ARCHITECT'S ADDENDUM

ADDENDUM NUMBER: 2

RE: Will County Recorder and Coroner

PREPARED BY: Cordogan Clark & Associates

EXISTING ROOF FRAMING & RTU ADDITION

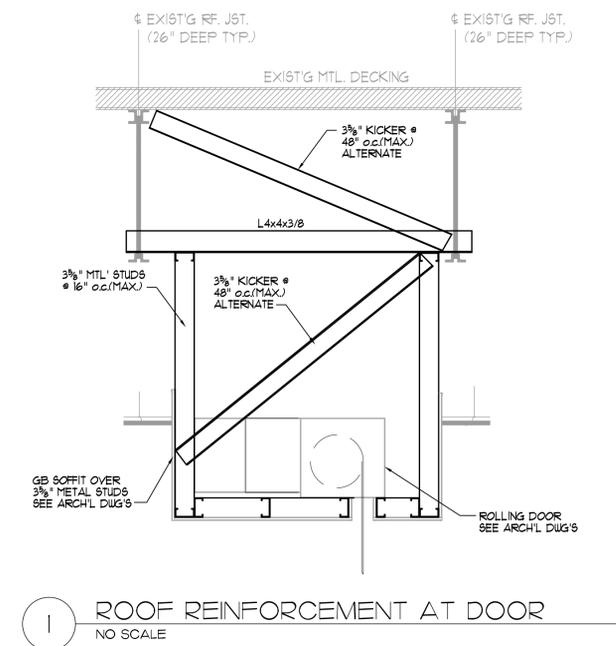
1. Sheet S1.1 and S2.1: Structural drawings: were ADDED . See attachment for drawings.
2. Sheet A2.0 Plan 1: Wall type A3 should read A4.
3. Sheet A2.0 Detail 4 Wall type A4 should read A3.
4. Sheet A2.0 Detail 3 Wall type A3 should read A4.
